Re: Barelas Townhomes, Engineer's Stamp Dated 5-11-07, (L14/D33)

**Re: Barelas Coffee House, 1423 Fourth St SW, Grading and Drainage Plan
Engineer's Stamp dated 1-22-07 (L14-D33)**

DRAINAGE REPORT
FOR
BARELAS TOWN HOMES

**Re: Barelas Coffee House, 1423 Fourth Street SW, Traffic Circulation
Layout**

DRAINAGE AND TRANSPORTATION INFORMATION SHEET
(Rev. 06/22/2005)

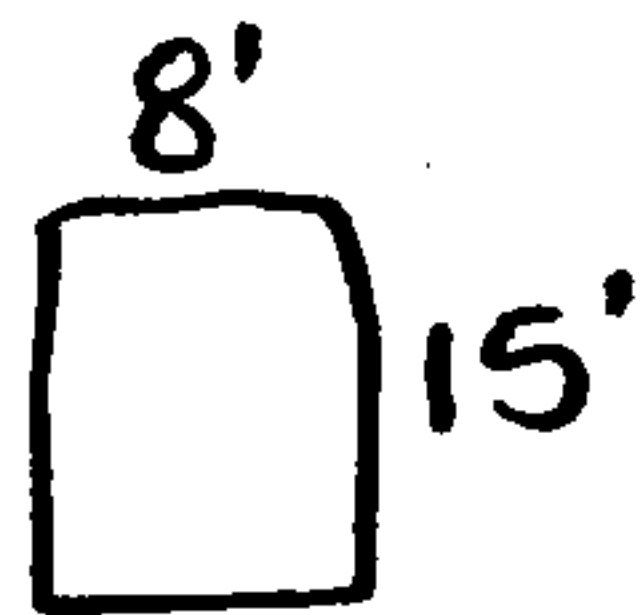
Need 2 copies

Ramps must comply w/ ADA stds

How can you only have 0 reg. spaces?

Enlarge ^{vicinity} map area

Are you trying to take access off alley?

Clarify

Width of SW

8' wide small car spaces

Up to 25% can be compact spaces

Label SC spaces "Compact"

4th St Arterial here - typically, reg
width — , can you get 30'?

do also 2 properties? Cross lot access?

Width of all SW

Spaces cannot have 2' overhang into alley

if replacing curb, will need to replace
SW as well
